DESIGN REVIEW BOARD DECISION

DATE: December 1, 2022
FILE NUMBER: DRV22-00466
PROJECT NAME: Swyft Mixed-Use
APPLICANT: Marc Boettcher, with MSPT CIII LLC
PROJECT PLANNER: Aoife Blake, Associate Planner

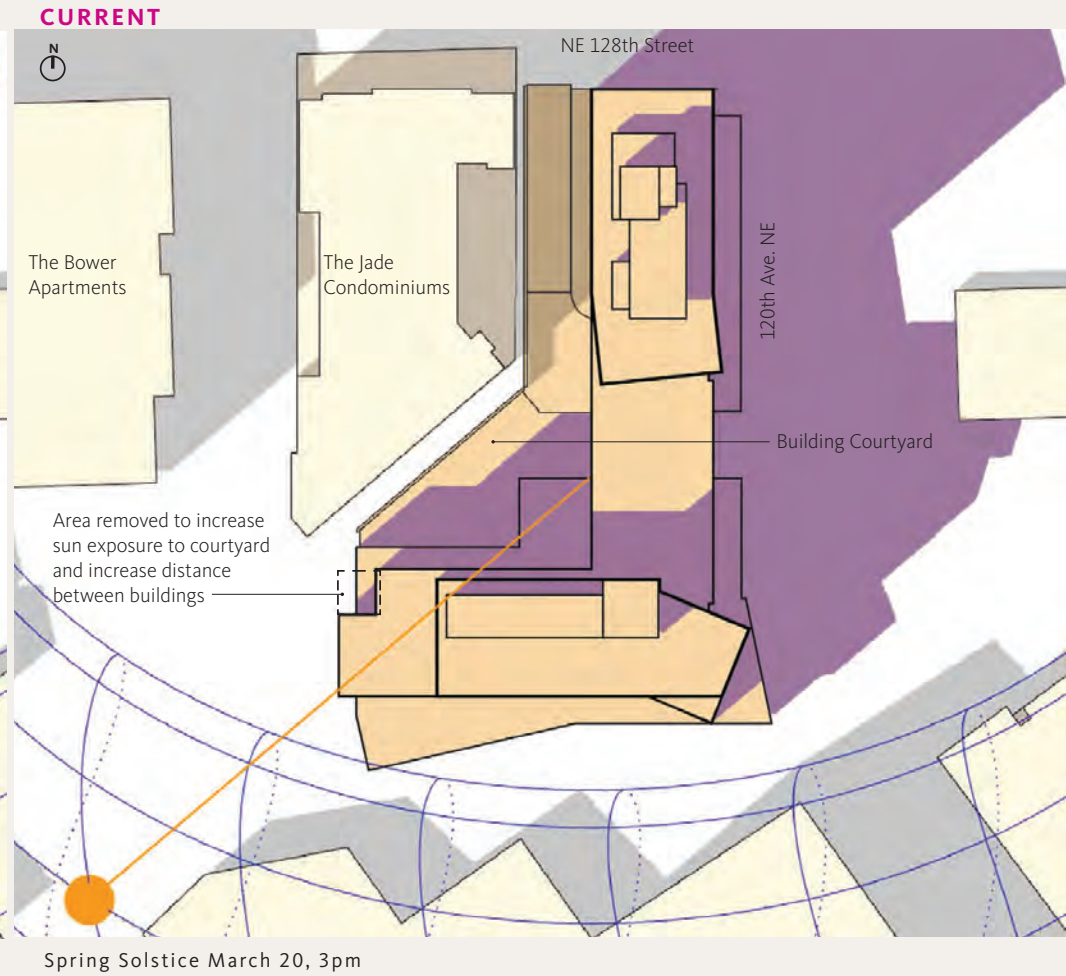
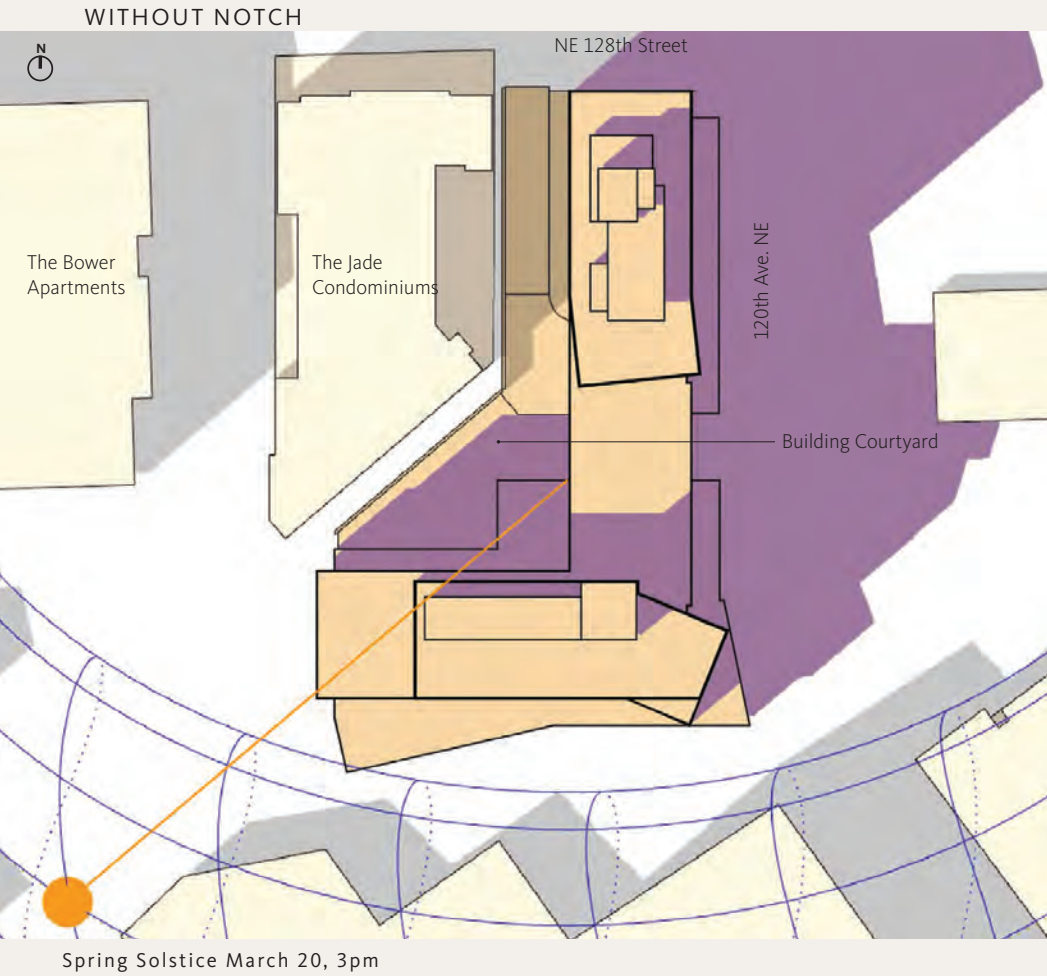
DRB noted some issues around the suitability of the mass on the north side and around how to mitigate the mass of the building. They suggested more refinement is needed as the project design develops to break up the mass of the building. Encouragement to look at a “two-tower” massing concept for complimentary scale to adjoining neighborhood. The applicant was encouraged to explore design approaches in the SW corner of the building, suggesting narrower and greater height.

Request to further refine the South building to address light and privacy to the Jade and courtyard. DRB expressed concern in terms of light and privacy in relationship to the Jade wanted further exploration.

The design team has incorporated a “two-tower” scheme by making refinements to the southern mass through several design changes:

- 01 The upper levels were made more narrow, locking the volume into the SW corner and breaking up the upper level massing.
- 02 The tower was extruded upward by two levels to better compliment the adjoining neighborhood and provide a more fluid transition in height between the existing building on the South and the two proposed stepped tower masses.
- 03 Removed podium mass to increase distance at adjacent building,
- 04 Increased level of privacy and increasing solar penetration
- 05 Facade articulation applied to further break down buildings masses into distinct elements
- 06 Refinement of pedestrian frontage incorporating detail and art
